WALDEN PRESERVE 2

Filing No. 4

Grading & Erosion Control Plans

PCD FILE NO. SF-18-034

SHEET: C4

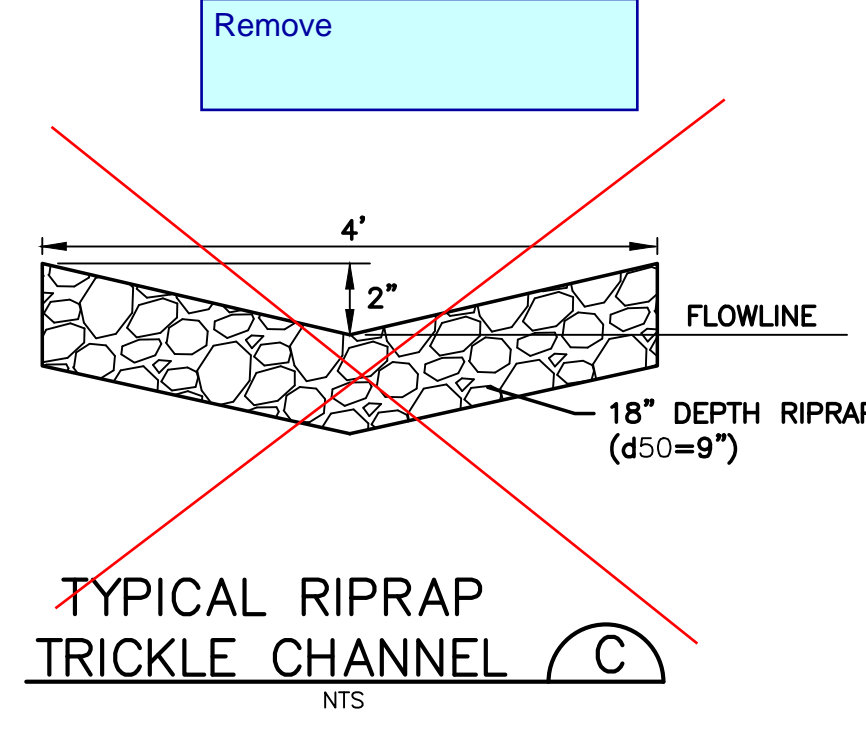
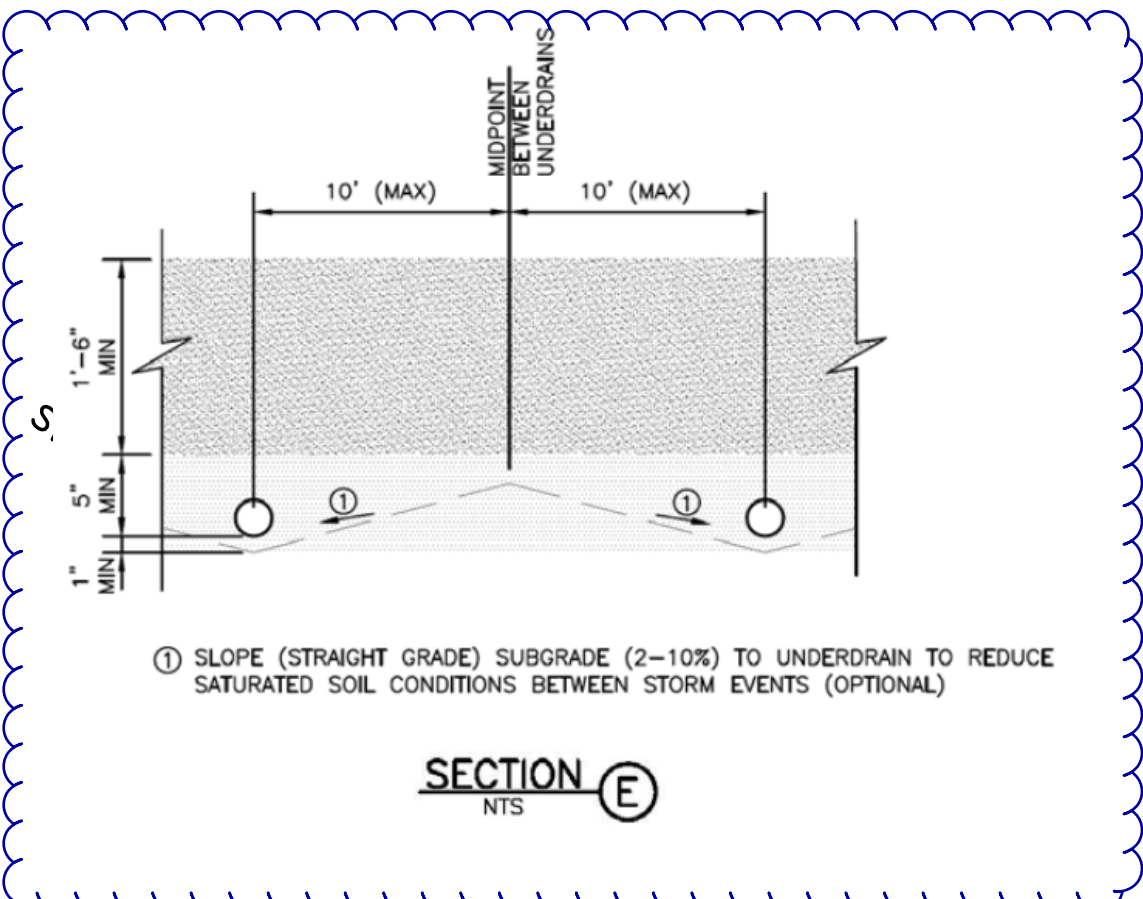
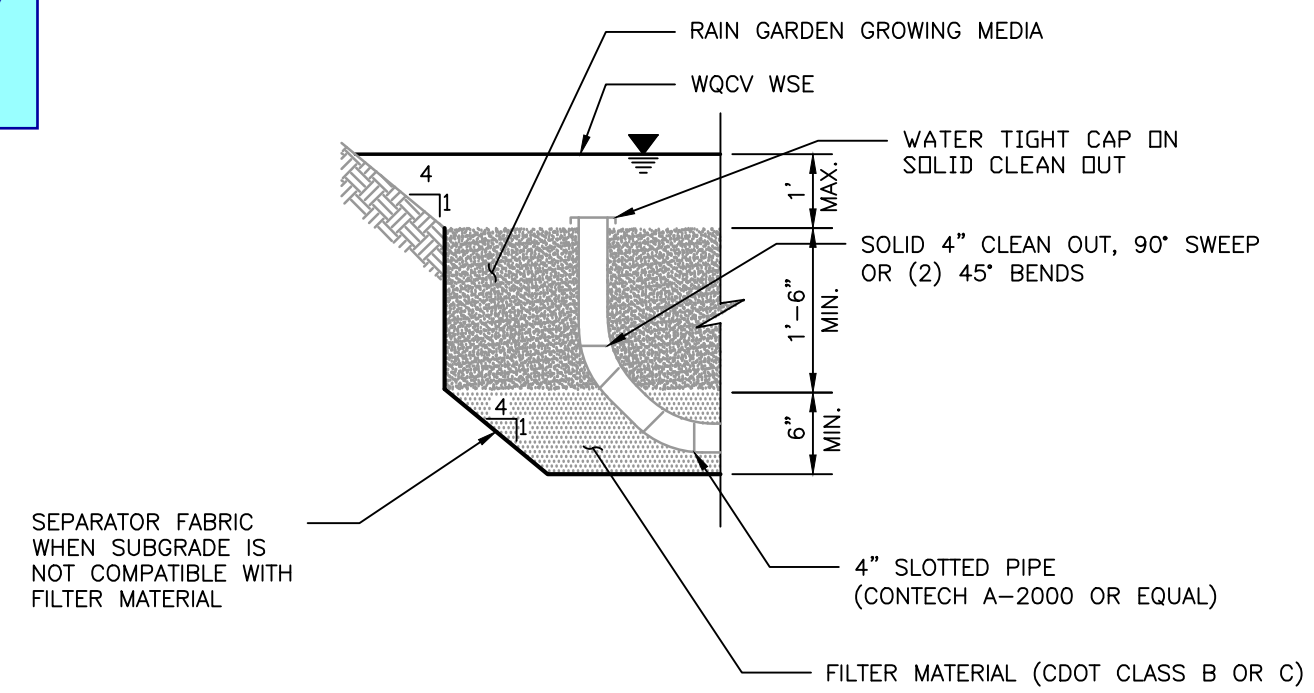
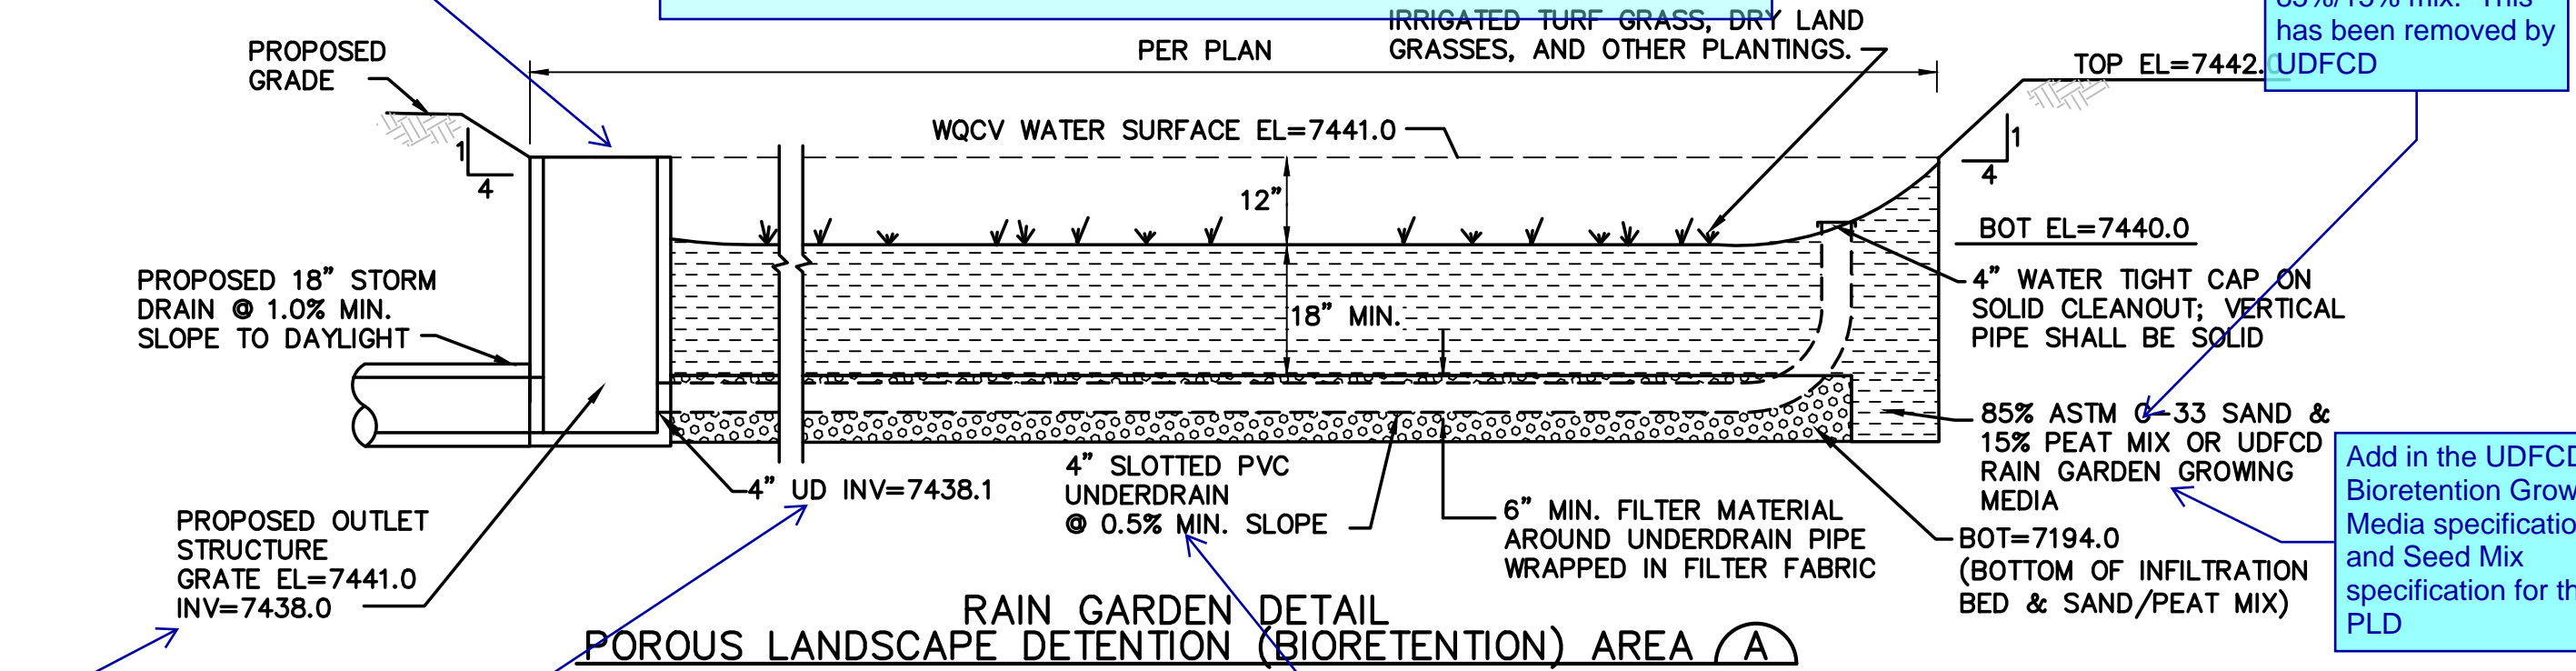
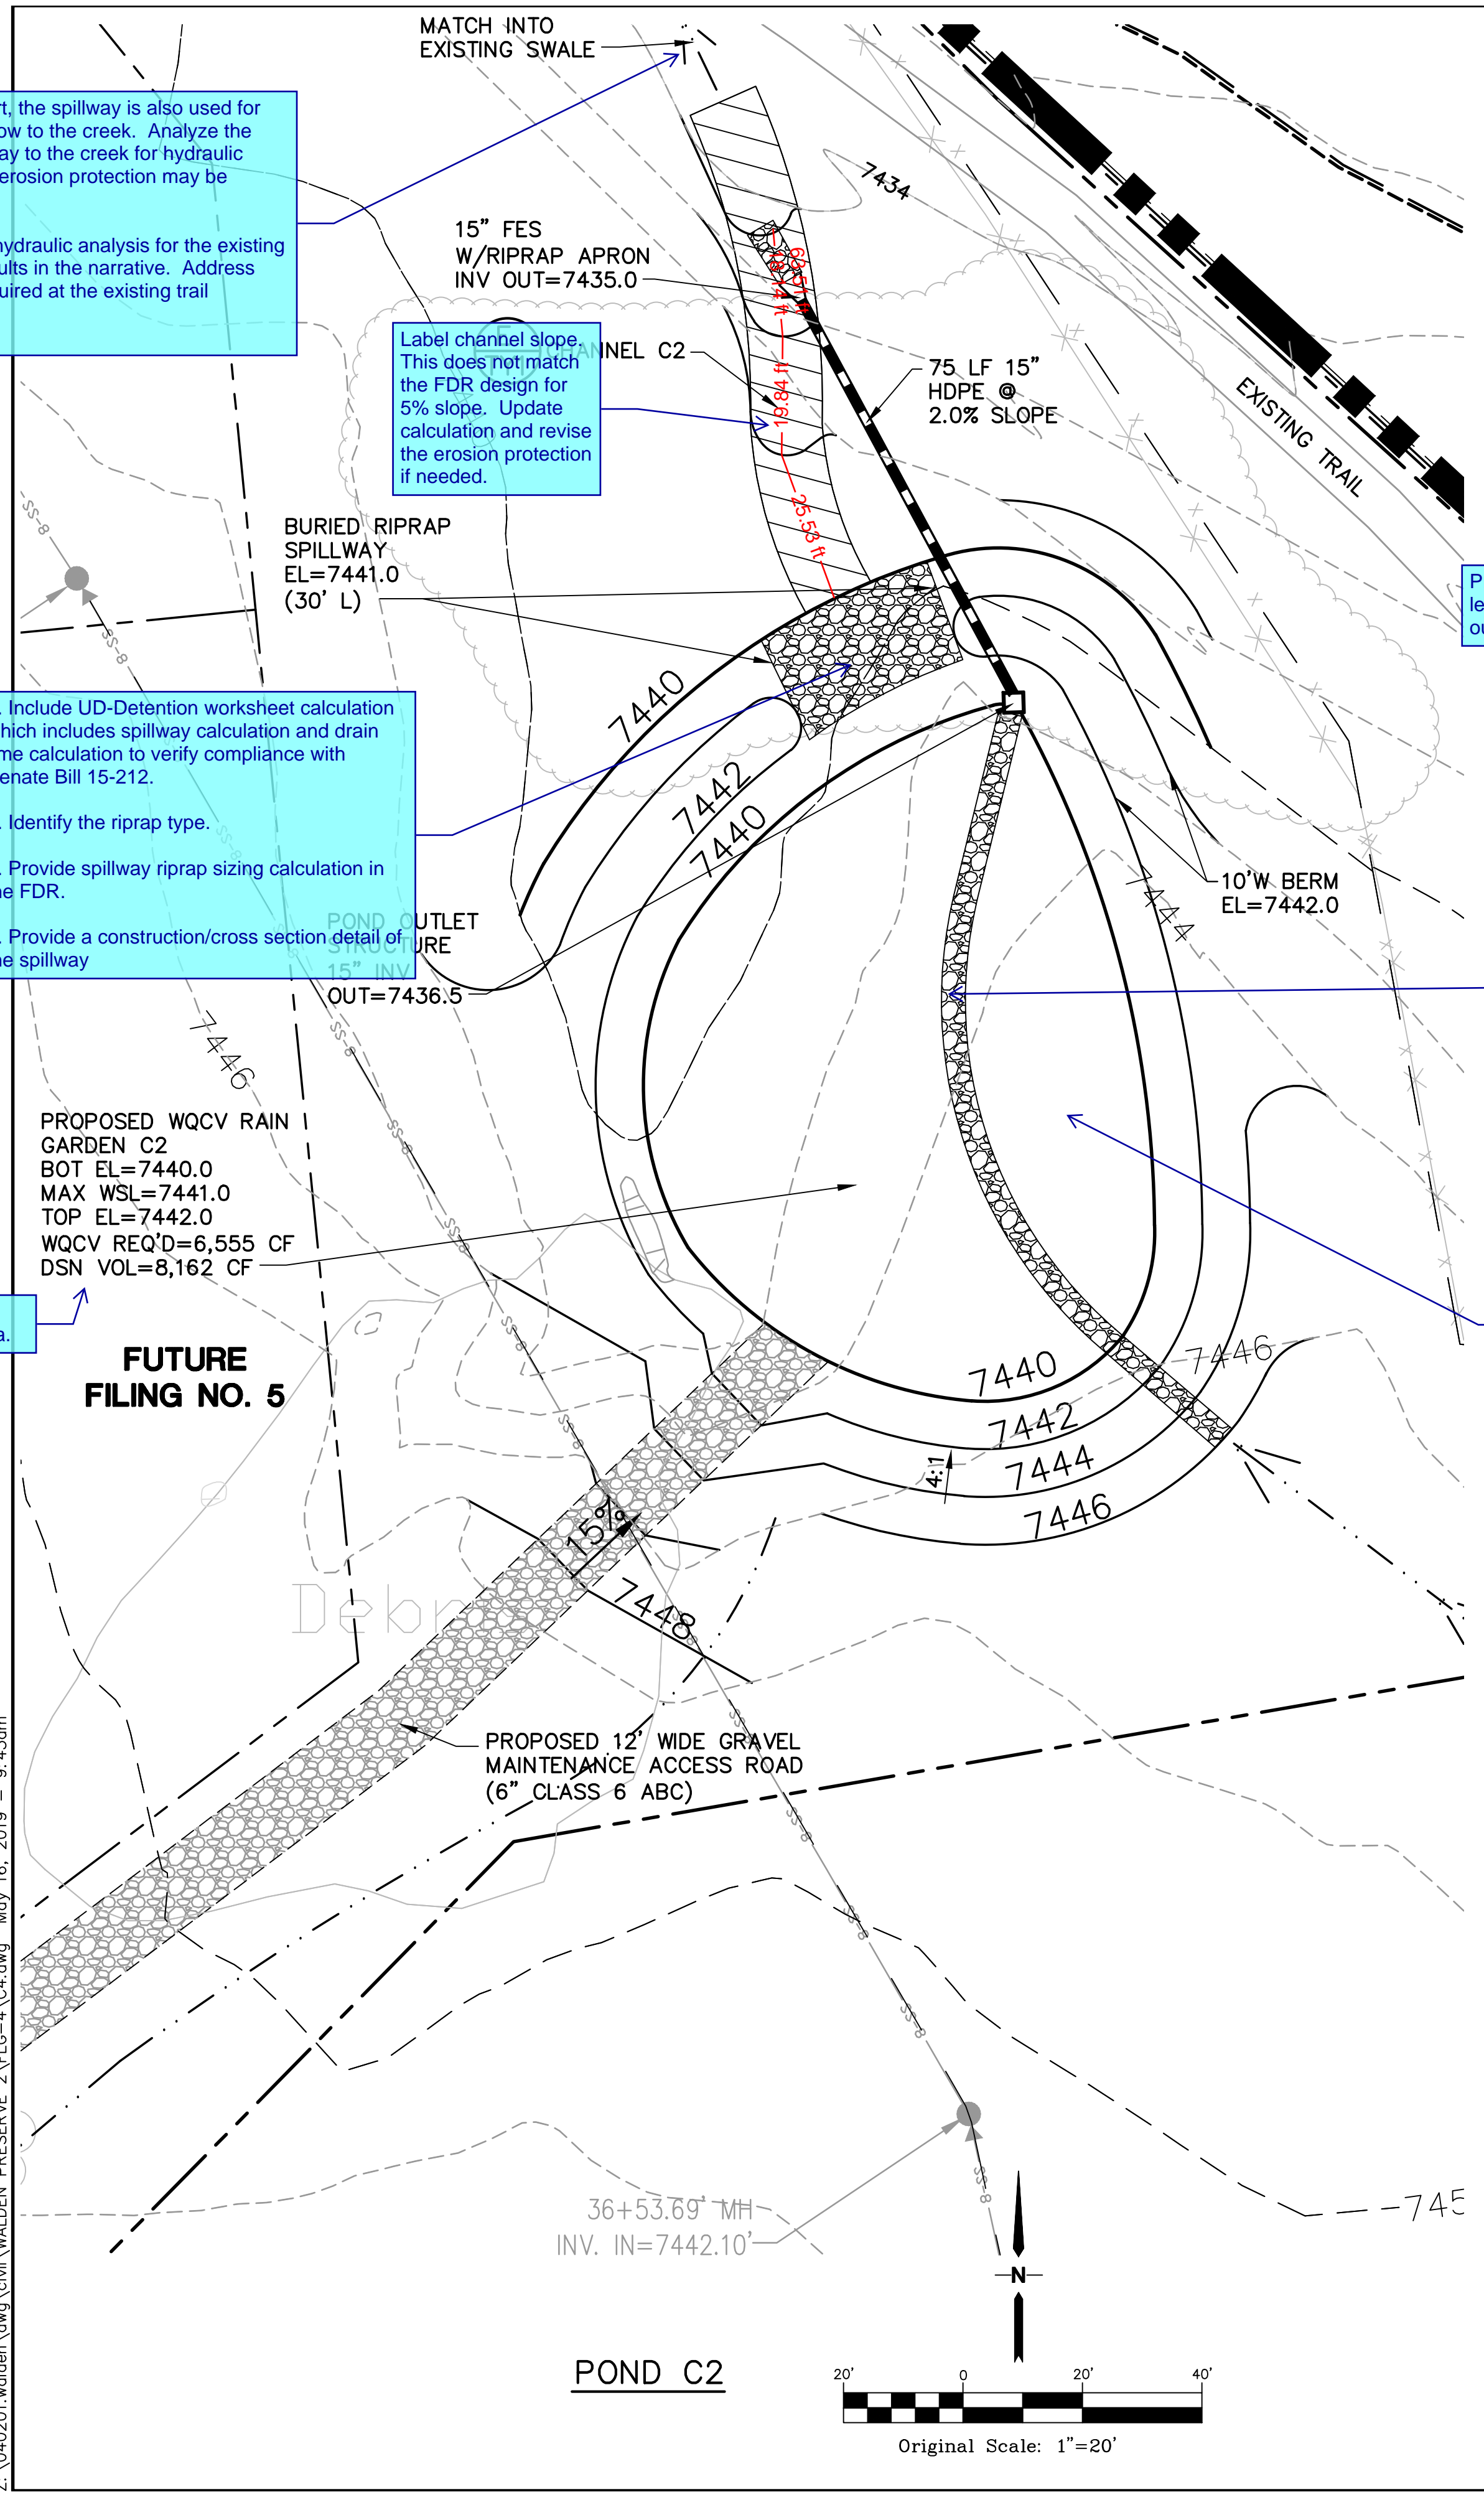
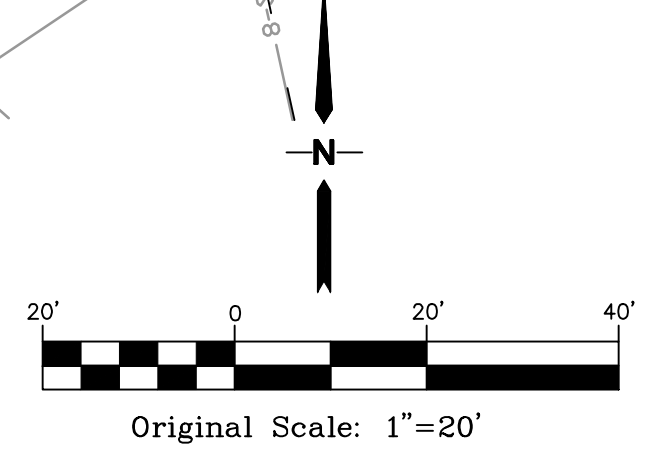
Review 2: Pond outlet structure will be reviewed on the re-submittal. Changes to the construction details is likely based on comments to the drainage report.
 Review 3: Pond was redesigned to Porous Landscape. See new comments.

Per the drainage report, the spillway is also used for conveying the 100yr flow to the creek. Analyze the section from the spillway to the creek for hydraulic adequacy. Additional erosion protection may be required.
 Unresolved. Provide hydraulic analysis for the existing swale and discuss results in the narrative. Address whether erosion is required at the existing trail crossing.

Label channel slope. This does not match the FDR design for 5% slope. Update calculation and revise the erosion protection if needed.

1. Include UD-Detention worksheet calculation which includes spillway calculation and drain time calculation to verify compliance with Senate Bill 15-212.
2. Identify the riprap type.
3. Provide spillway riprap sizing calculation in the FDR.
4. Provide a construction/cross section detail of the spillway

List required and designed filter area.

Identify the grate used.

Add note specifying the compaction of the filter material to avoid over compaction of the filter area.

Remove the 85%/15% mix. This has been removed by UDFCD

Add in the UDFCD Bioretention Growing Media specification and Seed Mix specification for the PLD

Provide construction level detail of the outlet structure

Install the restrictor (1-7/8" diameter) per the UD-BMP calculation.

Provide additional specification (slot width, min open area, ASTM standards or identify a specific product meeting the specifications in UDFCD Table B-1

Remove Trickle Channel. Not applicable for PLD's

The filter area is fairly large; therefore show the underdrain layout and add the following detail (modify as necessary to meet your design)
